**DEVIATION REQUEST
 AND DECISION FORM**

Project Name : **Retreat at PrairieRidge Filings 1-3 Preliminary Plan**
 Schedule No.(s) : 52280-00-024 & 52280-00-025
 Legal Description : See attached

A deviation from the standards of the ECM in **Chapter 2.2.5.E** is requested.

RETREAT AT PRAIRIERIDGE FILINGS 1-3			
PRELIMINARY PLAN			
FILING 1 & 2			
DESIGNED BY	MAW	SCALE	DATE 5/29/2024
DRAWN BY	MAW	(H) 1" = 60'	SHEET 6 OF 28
CHECKED BY	(V) 1" = N/A	JOB NO.	1305.10

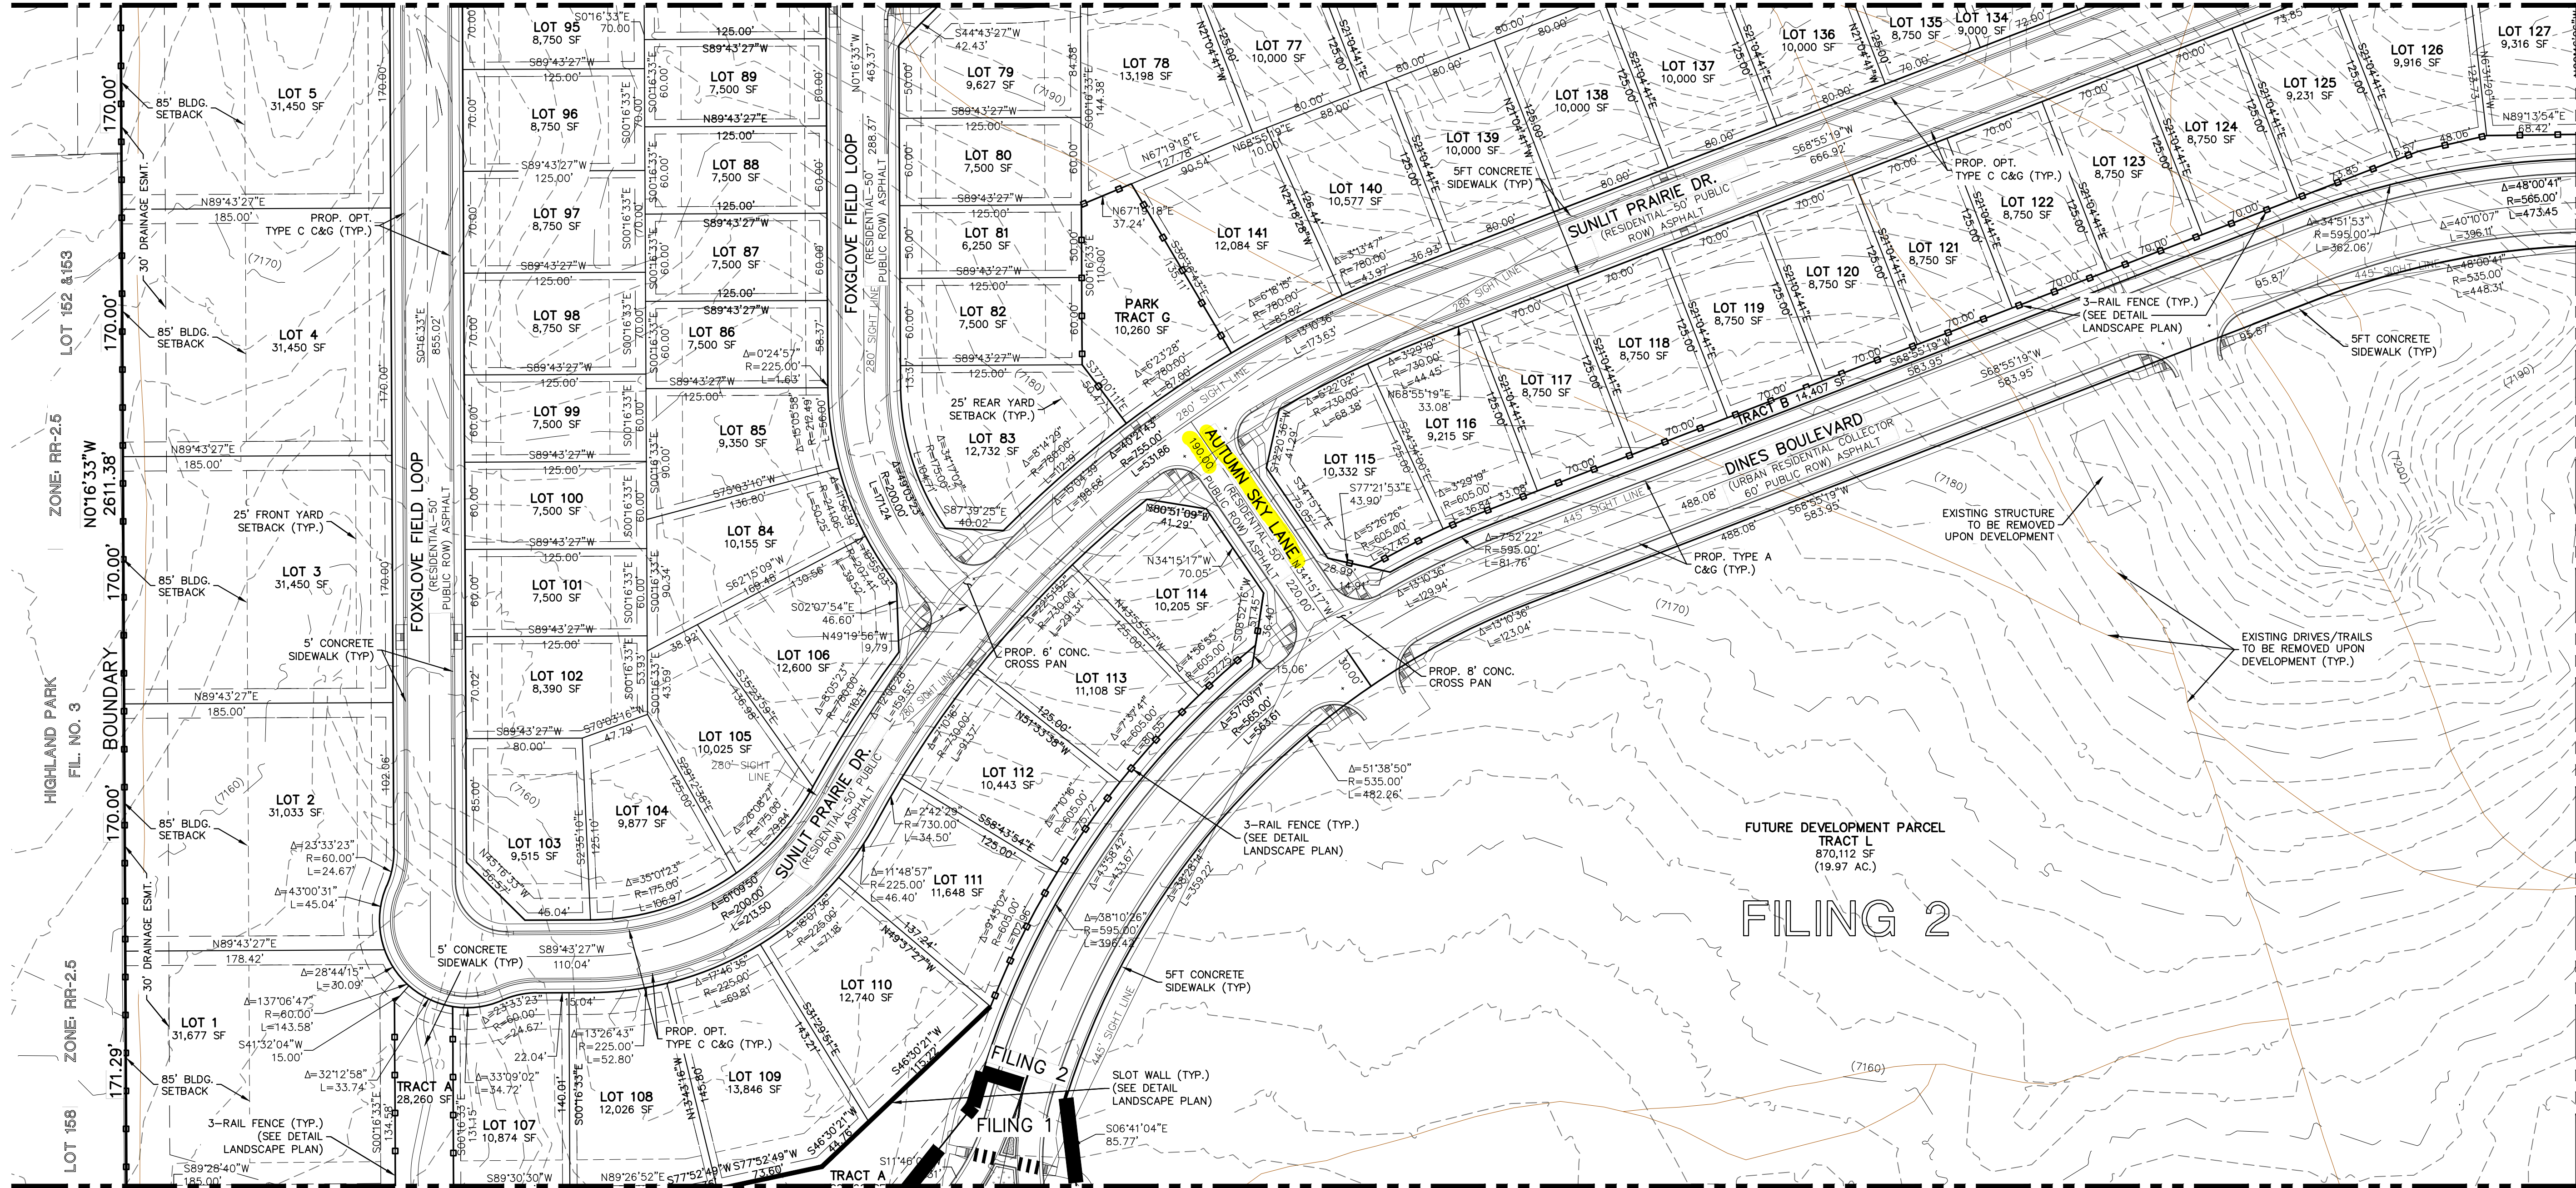
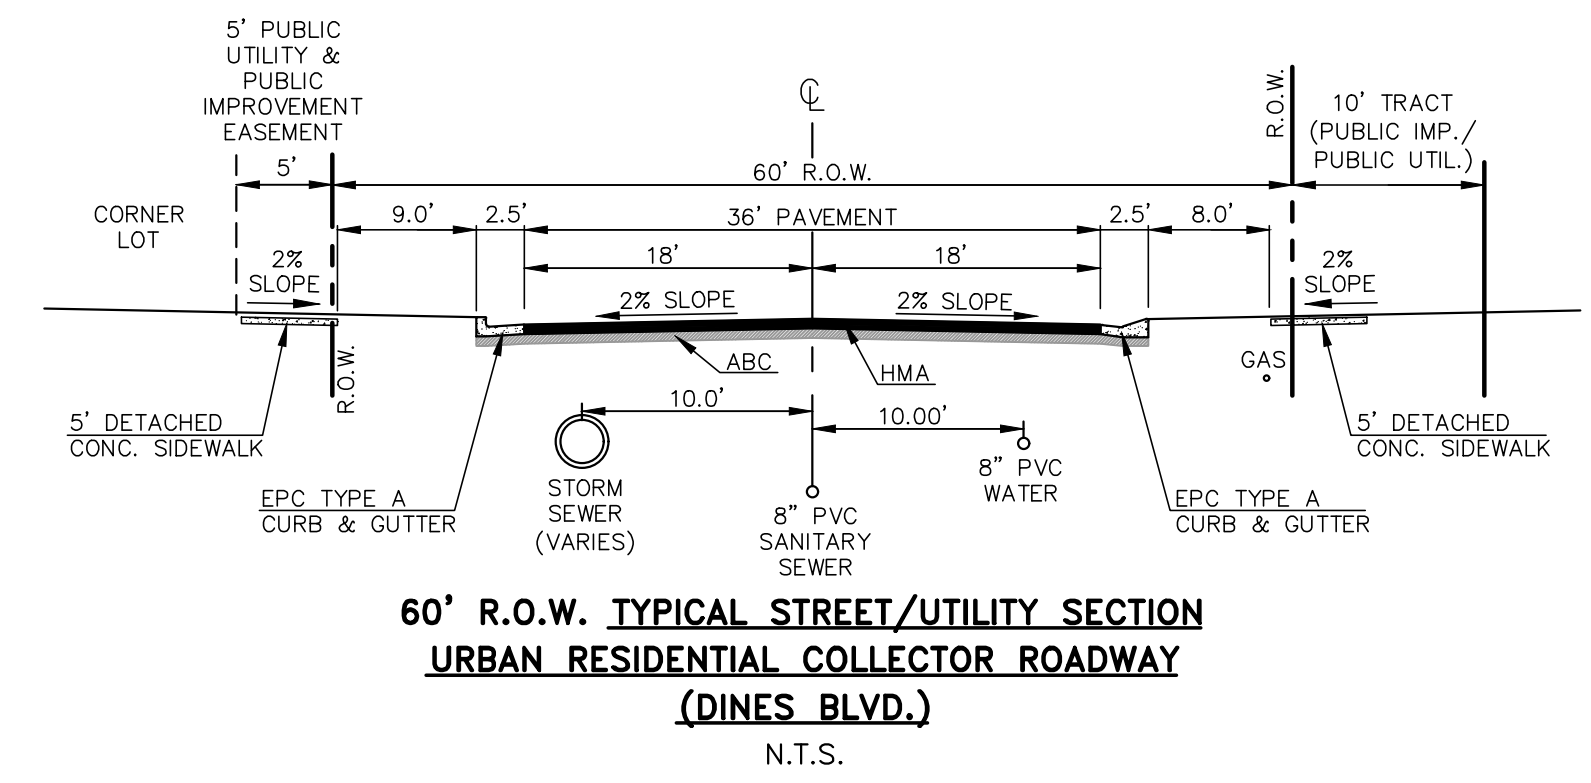
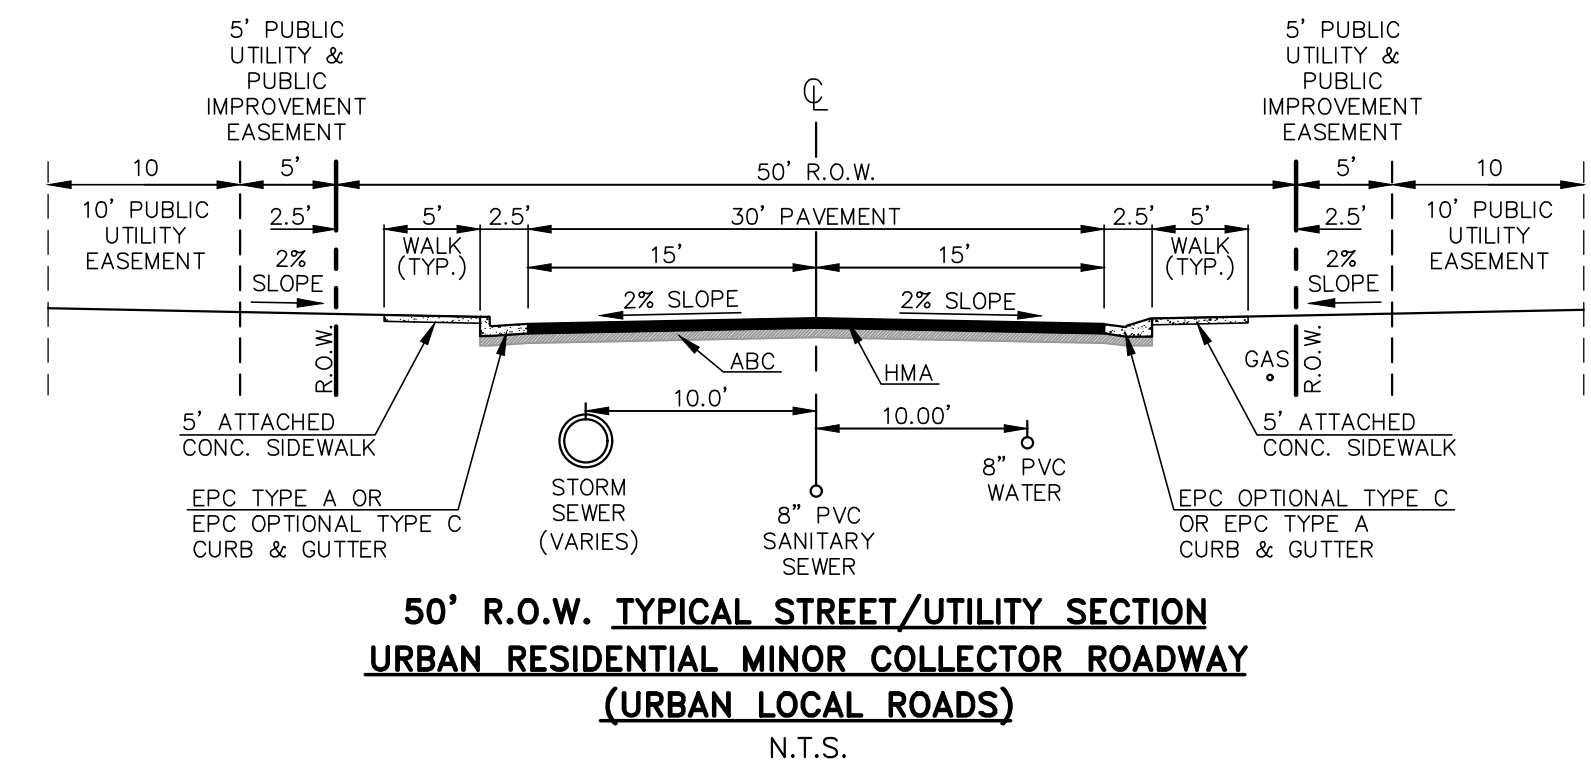
An urban local intersection is planned 190' away from collector road (CL to CL) rather than the required 200'. This design is based on a standard single family lot depth of 125' along with a 10' tract adjacent to the collector road. (Reference the Preliminary Plan – Autumn Sky Lane connection between Dines Blvd. and Sunlit Prairie Dr.)

The proposed alternative is to maintain a reasonable lot depth of 125' along with a 10' open space tract adjacent to the collector roadway as required for double frontage lots. This CL-CL distance between intersections then equals 190' rather than the 200' criteria.

In urban single family developments it is standard practice to have typical lot depths or 100'-120'. In this portion of the project, the lots are double frontage lots and an additional open space tract (10' in this case) is planned adjacent to the collector roadway. Thus, the 125' lot depth and 10' tract determined the 190' CL-CL spacing. (Reference the Preliminary Plan – Autumn Sky Lane connection between Dines Blvd. and Sunlit Prairie Dr.)

The Autumn Sky Lane access off of Dines Blvd. is only 10' shorter than criteria requires. This still leaves the ability to stack 4-5 cars at the stop sign at Autumn Sky Lane and Sunlit Prairie Dr. without affecting traffic on Dines Blvd.

This request has been determined to have met the criteria for approval. A deviation from Chapter 2.2.5.E of the ECM is hereby granted based on the justification provided.

RETREAT AT PRAIRIERIDGE FILINGS 1-3			
	PRELIMINARY PLAN			
FILING 1				
DESIGNED BY	MAW	SCALE	DATE	5/29/2024
DRAWN BY	MAW	(H) 1" = 60'	SHEET	8 OF 28
CHECKED BY		(V) 1" = N/A	JOB NO.	1305.10

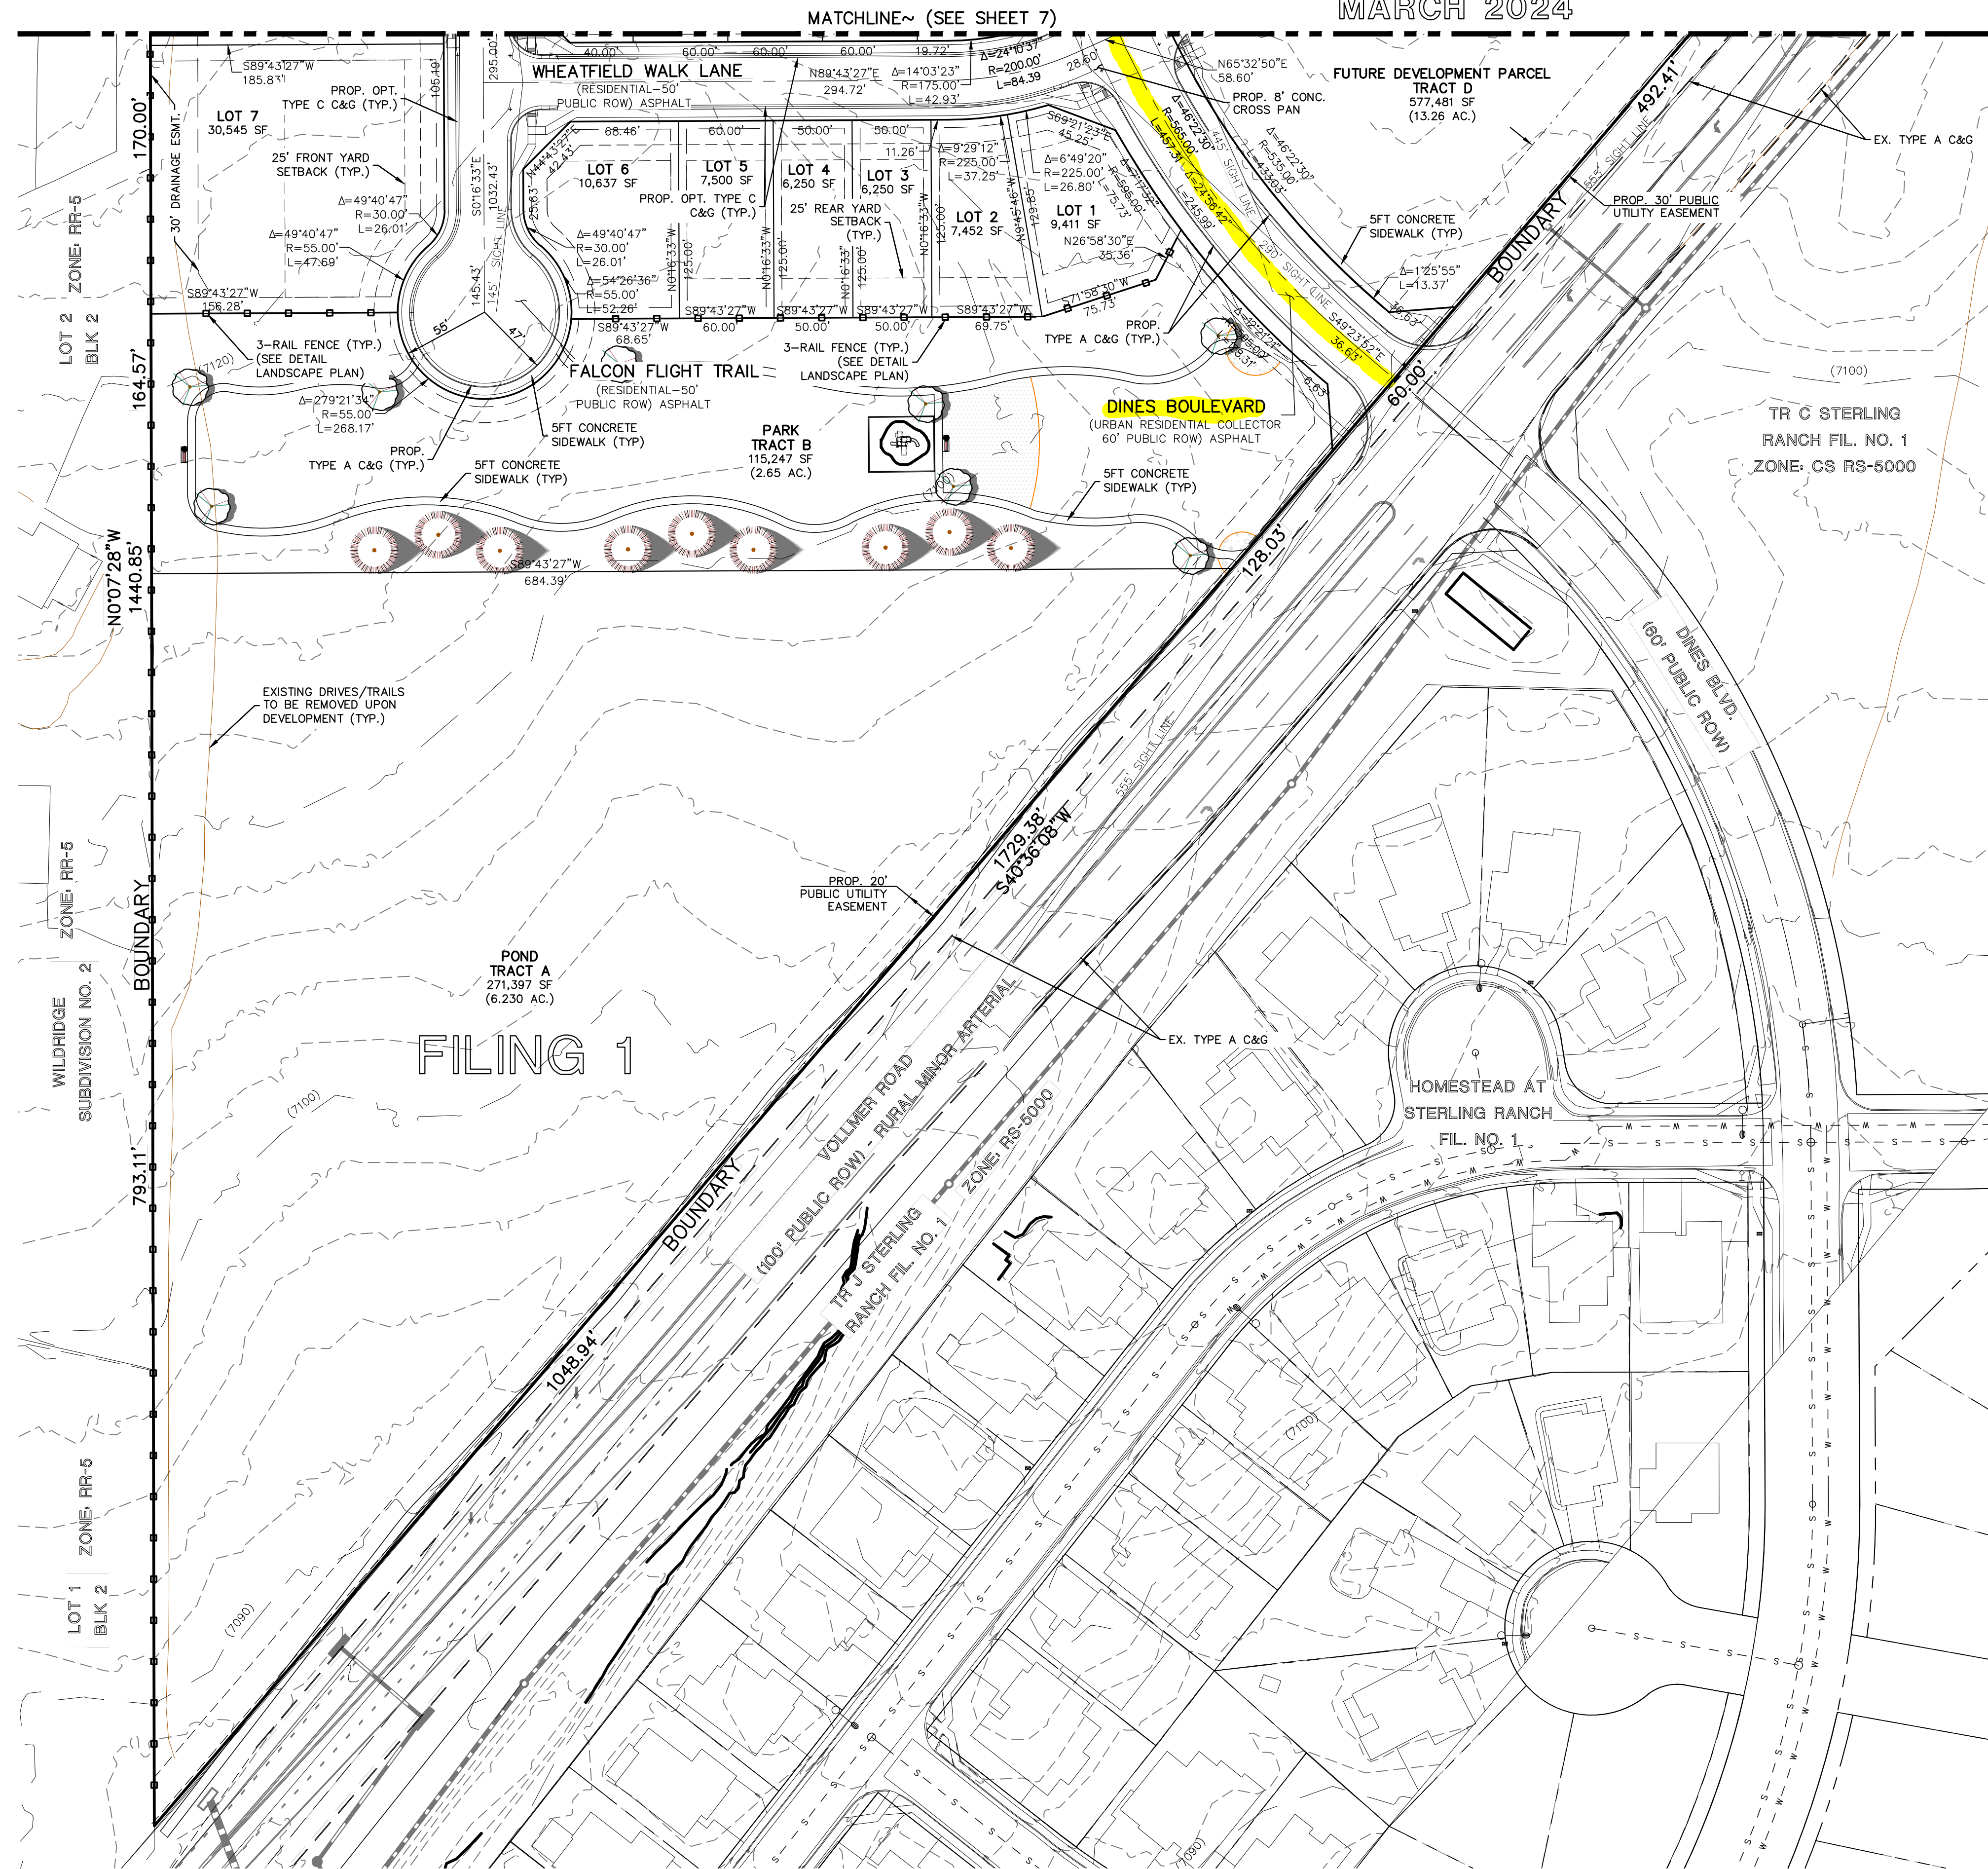
An urban local intersection is planned 282' away from a rural arterial (ROW to CL) rather than the required 330'. This design again is based on a standard single family lot depth of 125' along with a park tract adjacent to the arterial road. (Reference the Preliminary Plan – Dines Blvd. connection between Wheatfield Walk Lane and Vollmer Road)

The proposed alternative is again to maintain a reasonable lot depth of 125' along with a park tract between the lots and Vollmer Road as required by the 50' buffer and park as shown on the approved Jaynes Property Sketch Plan (SKP225) This ROW-CL distance between intersections then equals approximately 282' rather than the 330' criteria. Incidentally, the CL-CL distance equals 332'.

The southern portion of the project has a similar condition, however, there is a park planned between the lots and Vollmer Road. The 125' lot depths and the varying width of the park in this area determine the 282' ROW-CL spacing. (Reference the Preliminary Plan – Dines Blvd. connection between Wheatfield Walk Lane and Vollmer Road)

The Wheatfield Walk Lane access off of Dines Blvd. is 48' shorter than criteria requires. However, this still leaves the ability to stack 7-8 cars at the int. of Wheatfield Walk Lane and Dines Blvd. waiting to turn left without affecting traffic on Vollmer Rd. There is no stop condition on Dines Blvd. at this int.
